SEQUOYAH LICENSE

No. SUB-1010

Complete Page Index to License as Revised

PROCESS TECHNOLOGY AND EQUIPMENT

Fig. 3-2

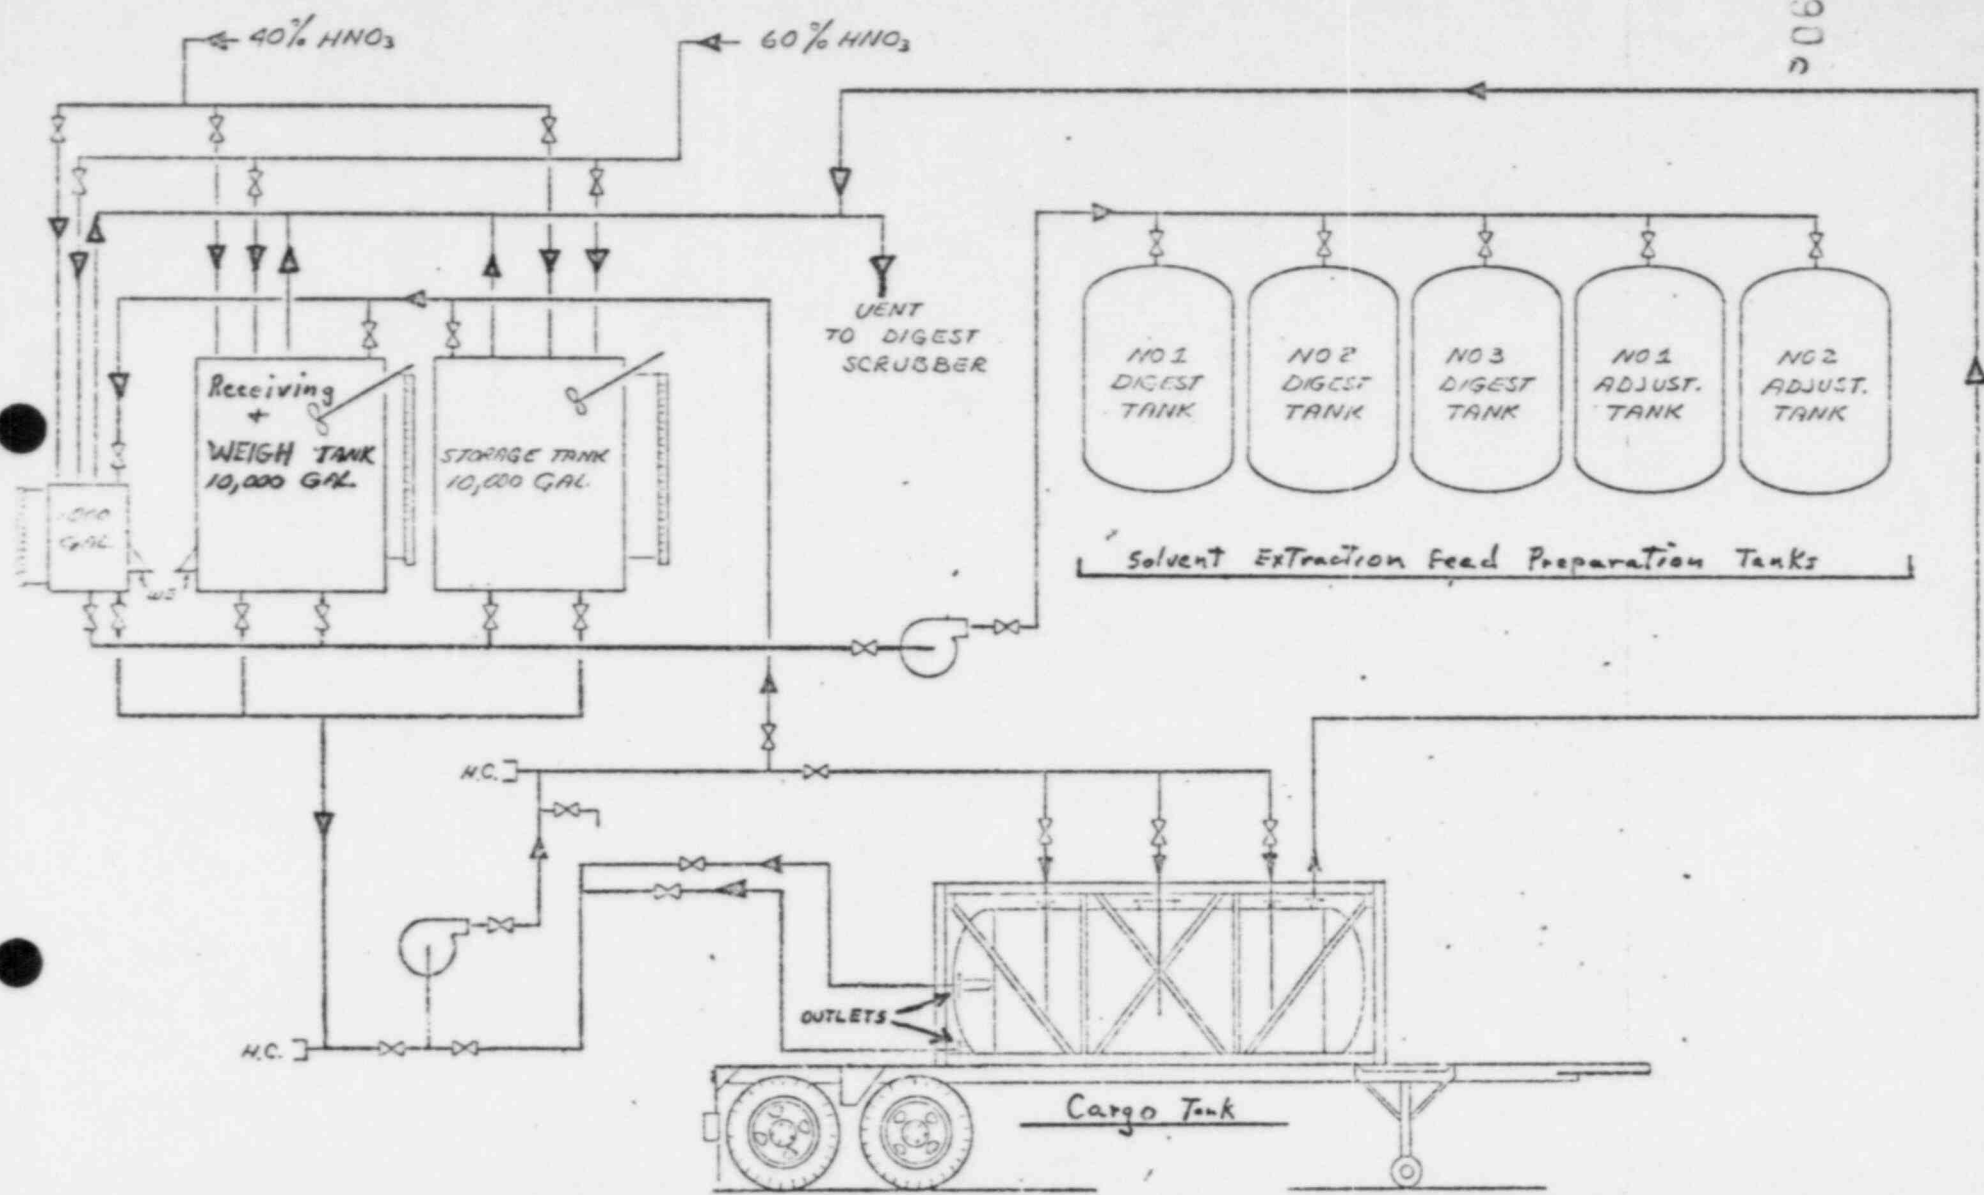
3.2.3.1 Unloading, Sampling and Digestion of Wet Yellowcake

Wet yellowcake slurry delivered from a uranium mill will contain approximately 38% (WT) of water. The slurry is transported in a stainless steel cargo tank meeting specification MC310, MC311, MC312 or MC331. A special yellowcake slurry receiving area is provided at the Sequoyah facility. This area contains facilities and equipment for dissolving the ADU slurry with nitric acid, unloading the cargo tank and sampling the uranyl nitrate solution. (See Fig. 3-2.)

Tanks for receiving, weighing and sampling the uranium product are enclosed in a building which rests on a concrete curbed foundation with sufficient volume to contain spillage in case of accidental release. There are three tanks provided; one 1,000 gallon tank and two 10,000 gallon tanks. The 1,000 gallon tank is used for non-routine, small operations and for calibration of the load cells on the 10,000 gallon receiving and weigh tank. The second 10,000 gallon tank is used for measured storage. The receiving and transfer pumps are contained in a small building with a curbed foundation that drains to the large curb in case of spillage in the pump house. The area where the cargo tank is parked is also curbed adequately to contain

The cargo tank will arrive at the facility ~60% full, with blind flangs on all openings except the pressure relief valve (tank rated at 30 psi). The cargo tank will be "spotted" and the blinds removed. Three equally spaced pump discharge bayonets are inserted to within 3" of the bottom of the tank, and two pump suction lines are attached to two diptubes, one at the bottom and one 1/3 tank diameter from the top. The vent line and a fail-safe level switch are then attached.

A predetermined amount of either 60% or 40% HNO_3 is then pumped into the receiving tank. The receiving tank, cargo tank and receiving pump are valved to allow pumping acid into the cargo tank. The cargo tank vent valve is opened. The acid is now pumped into the cargo tank until the level switch indicates proper level. (High level shuts down the pump.) Valving is now changed to allow pumping from the upper outlet in the cargo tank. The pump is restarted, providing recirculation of acid in the cargo tank. When acid has been consumed, the contents of the cargo tank is pumped back to the receiving and weighing tank. The dissolving operation is repeated until the slurry is totally dissolved. The contents of the cargo tank is then pumped to the receiving tank using the lower outlet. The cargo tank may be acid rinsed before being disconnected and prepared for return to the shipper.

The Uranyl nitrate in the receiving tank is mixed, weighed, sampled, and then transferred to the 10,000 gallon storage tank. The storage tank contents is then pumped to the process tankage used to prepare the feed for solvent extraction purification.
